ADDENDUM No. 1

Date: November 7, 2019
To: All Bidders
From: **Jenkins•Peer Architects**
Charlotte, N.C.
Re: UNC Charlotte – Residence Hall Phase XVI
SCO ID: 18-18333-02A
JPA Project #: 18NCC016

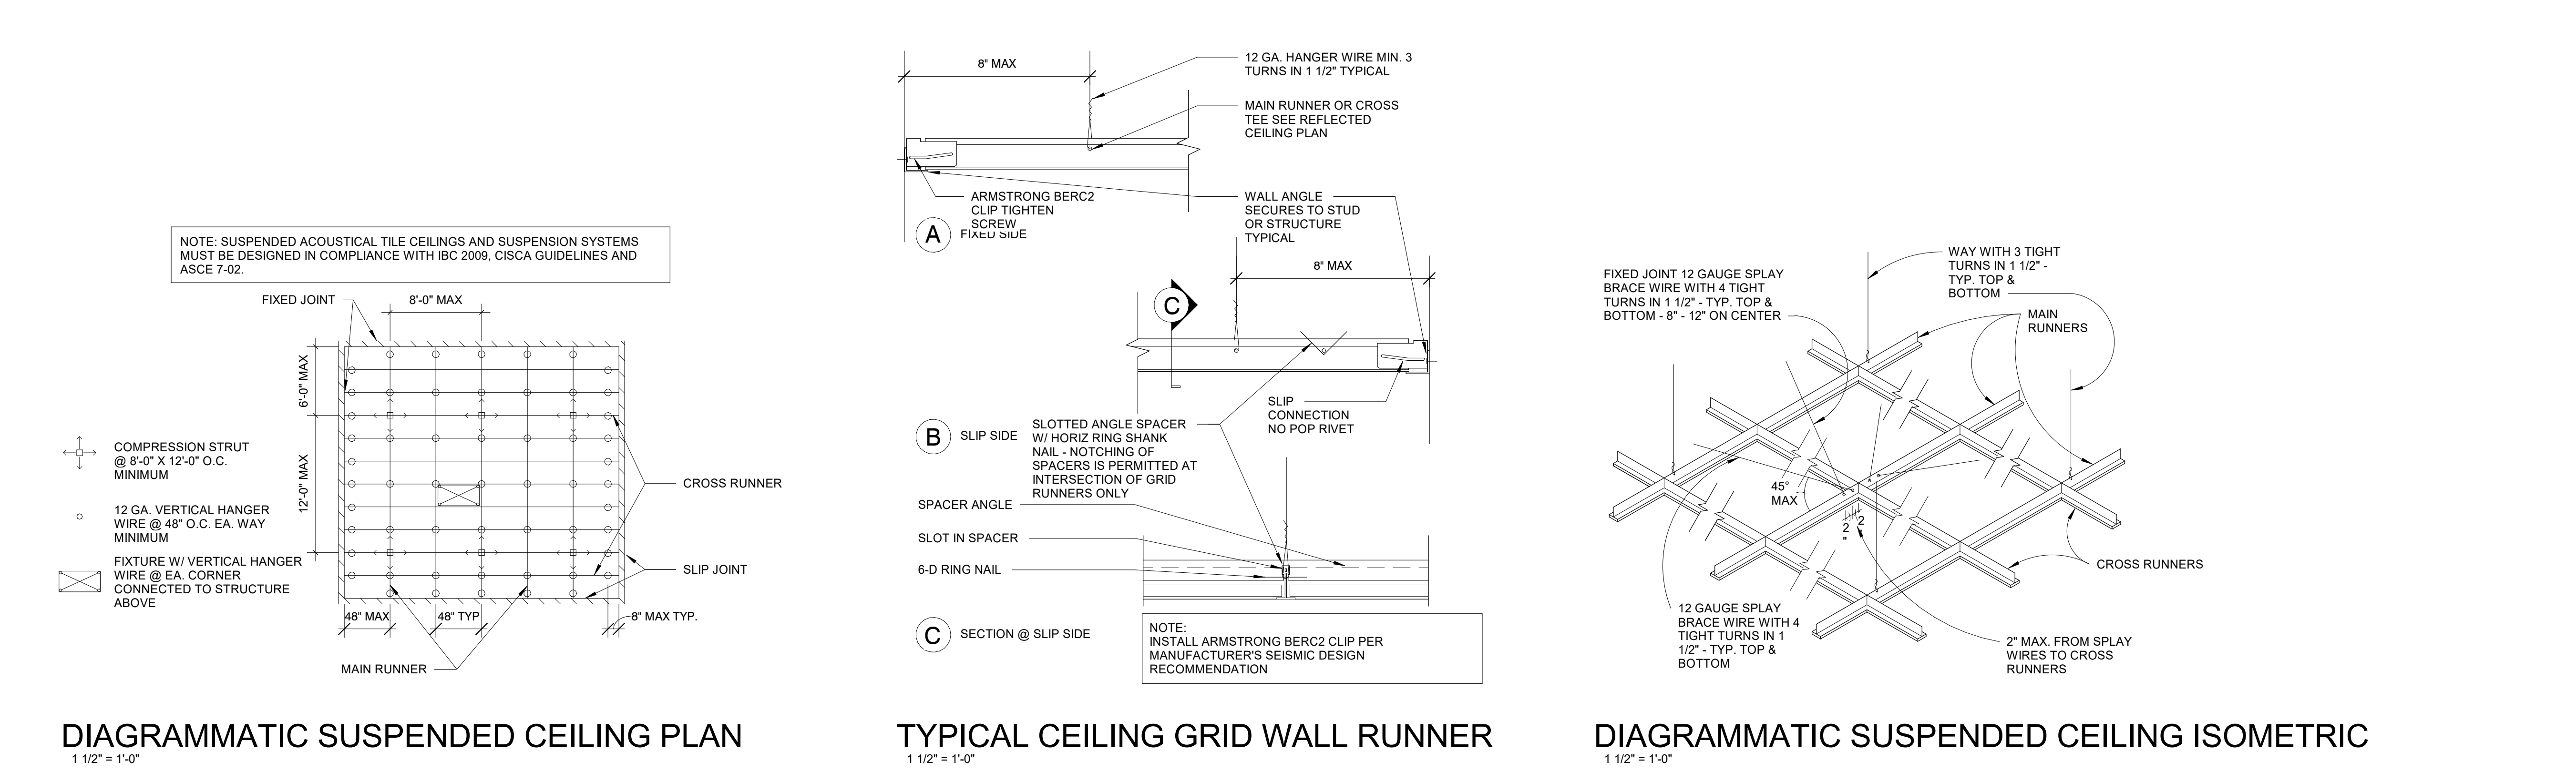
G-301 – Partition Types and Details – Updated with clouded revisions
G-302 – Partition Types and Details – Updated with clouded revisions
C4.00 – Utility Plan - Updated with clouded revisions

QUESTION: G301 and G302 call out metal studs to be 25 gauge. Specification 092900, 2.2, B, 1 notes these as 20 gauge. Please advise which is correct.

RESPONSE: Where wall types for acoustic walls require 25 ga. studs, please use 25 ga. as this is inherent to the acoustic properties of the wall. All other interior walls (non-acoustic) shall comply with specification requirements of min. 20 ga. studs.

UTILITY PLAN

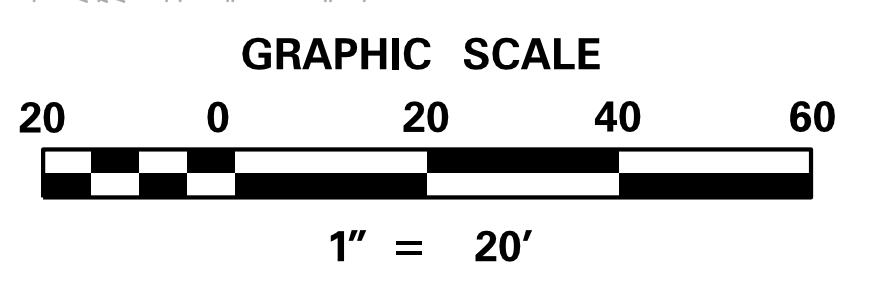
1. ALL PROPOSED SITE WORK NORTH OF SANFORD HALL LANE, INCLUDING THE NEW CURB AND GUTTER, SHALL BE PROVIDED AND INSTALLED BY OTHERS AND IS NOT IN CONTRACT (N.I.C.)
2. ALL NEW PAVING UP TO THE NEW CURB AND GUTTER IS PART OF THIS CONTRACT.
3. A NEW GAS LINE CONNECTION IN THIS AREA IS PART OF THIS CONTRACT AND MUST BE COORDINATED BETWEEN THE TWO PROJECTS.
4. A FOUNDATION DRAIN THAT DISCHARGES IN THIS AREA IS PART OF THIS CONTRACT AND MUST BE COORDINATED BETWEEN THE TWO PROJECTS.
5. ALL WORK INSTALLED IN THIS AREA BY OTHERS MUST BE PROTECTED THROUGHOUT THIS CONTRACT PERIOD WITH ANY DAMAGED ITEMS REPLACED UNDER THIS CONTRACT.
